Informal document GRSP-54-07-Rev.1
(54th GRSP, 17 – 20 December 2013,
-agenda item 3(b))

**Proposal for Amendment [x] to global technical regulation
No. 9 (Pedestrian safety)**

**Proposal of further amendments to document
GRSP-54-07-Rev1,
Submitted by [xxx]**

Figure 5A: Corner of bumper (see paragraph 3.134.)

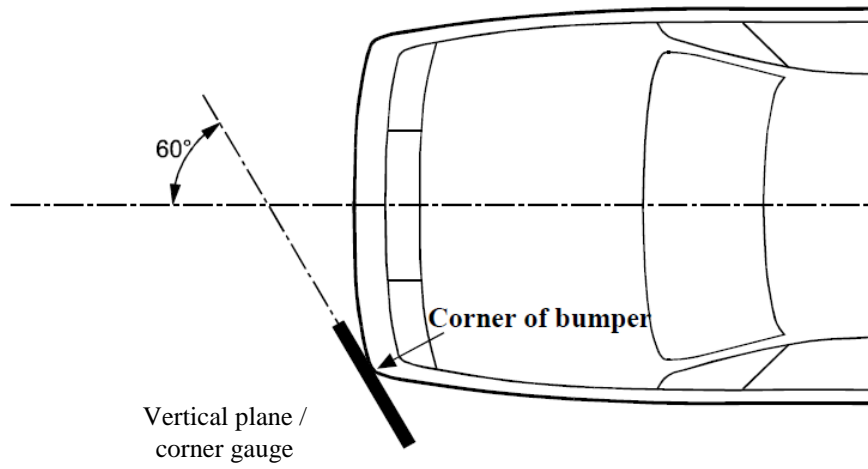
3.14. "Corner of bumper" means ~~the vehicle's point of contact with a vertical plane which makes an angle of 60° with the vertical longitudinal plane of the car and is tangential to the outer surface of the bumper (see Figure 5).~~ **the most outboard point on the outer surface of the front fascia of the vehicle. The transversal position of the point is determined in accordance with paragraph 3.14.1. (see Figure 5A).**

Figure 5B: Corner Gauge

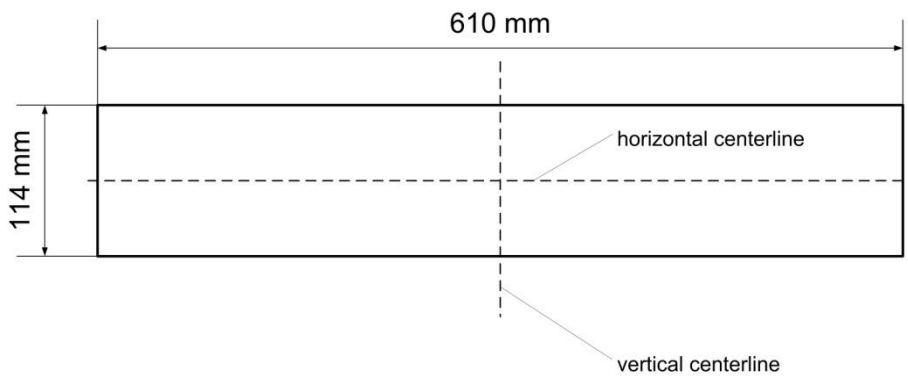
3.14.1. **The transversal position of the corner of bumper is determined with a corner gauge with dimensions as indicated in Figure 5B.**

Figure 5C: Determination of Corner of Bumper with the corner gauge

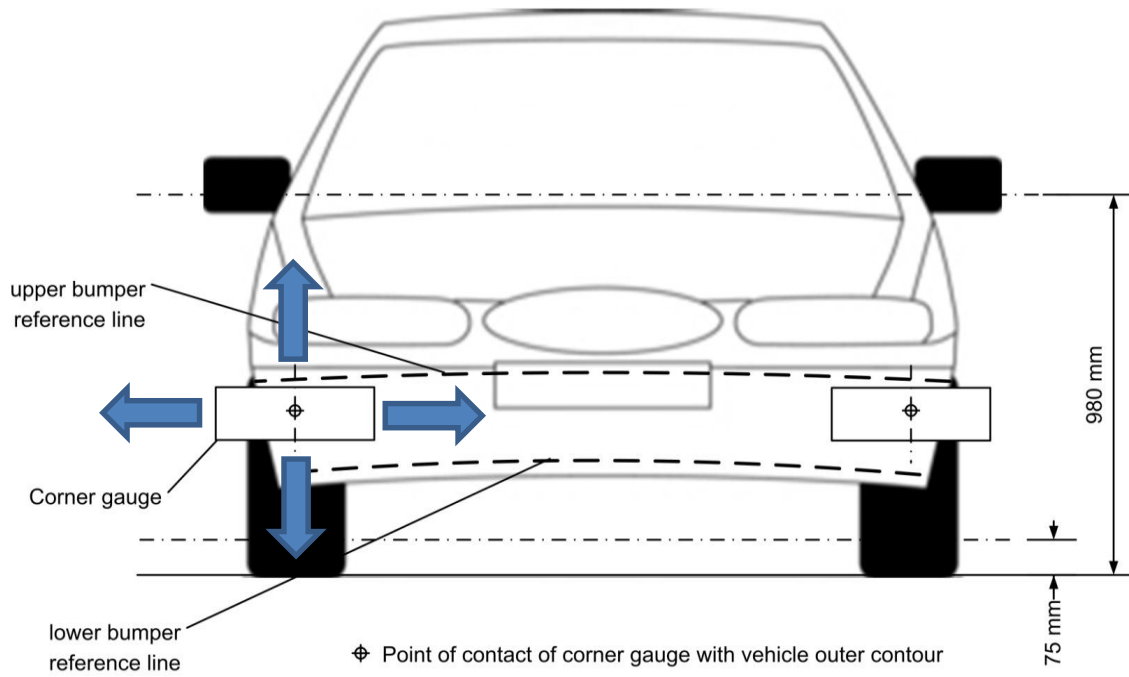
For the determination of the corner of bumper for the lower legform to bumper test, the main flat surface of the corner gauge is moved parallel to a vertical plane forming an angle of 60° to the vertical longitudinal median plane of the vehicle (see Figures 5A and 5C) between the following heights: with the bottom edge of the of the corner gauge at a height (± 10 mm) corresponding with the lowest point found in $-Z$ direction on the LBRL or at 75 mm above the ground reference plane, whichever is higher, and with the top edge of the corner gauge at a height (± 10 mm) corresponding with the highest point found in $+Z$ direction on the UBRL, not exceeding 980 mm above the ground reference plane.

For the determination of the corner of bumper for the upper legform to bumper test, the main flat surface of the corner gauge is moved parallel to a vertical plane forming an angle of 60° to the vertical longitudinal median plane of the vehicle (see Figures 5A and 5C) between the following heights: with the bottom edge of the of the corner gauge at a height (± 10 mm) corresponding with the lowest point found in $-Z$ direction on the LBRL and with the top edge of the corner gauge at a height (± 10 mm) corresponding with the highest point found in $+Z$ direction on the UBRL.

For determination of the corner of bumper, the gauge is moved while in contact with the outer contour of the vehicle, touching at the vertical centreline of the gauge.

The corner of bumper is defined as the most outboard point of contact of the gauge with the front fascia of the vehicle according to this procedure.
